5 April 2013

**Re: Materials Recycling Facility – Moorebank (05_0157)
Exhibition of Environmental Assessment**

Figure 1: Liverpool Local Environmental Plan 2008 – Zoning Map

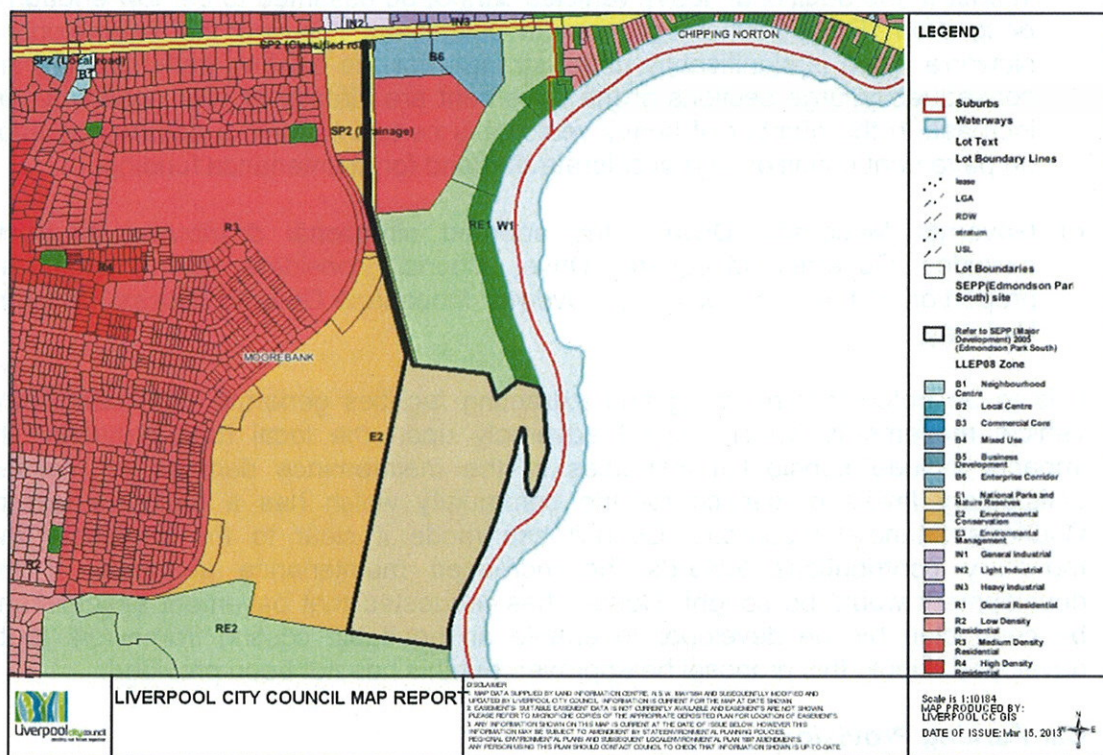
developments that would use the link off Brickmakers Drive. This development is adjacent to the proposed marina at 146 Newbridge Road (DA-846/2012) and the residential development to the north of the subject site. Further there are enterprise corridor and additional retailing on 124 Newbridge Road that will be accessed from this point. It is intended that all three developments will use the proposed link road. Table 10-3 of the environmental assessment calculates the number of traffic movements in 2021 resulting from full development of Georges Fair. It fails to account for future developments such as the residential development north of the subject site (Figure 1) and the proposed marina.

Therefore, the traffic assessment and the intersection performance analysis of the proposal should therefore take into the consideration the cumulative traffic impact of the three proposed developments that will use the road link. This will allow the determination of the most appropriate intersection treatment to accommodate all vehicles that will use the proposed intersection. In this regard an intersection with Give Way control is considered unacceptable in the medium term.
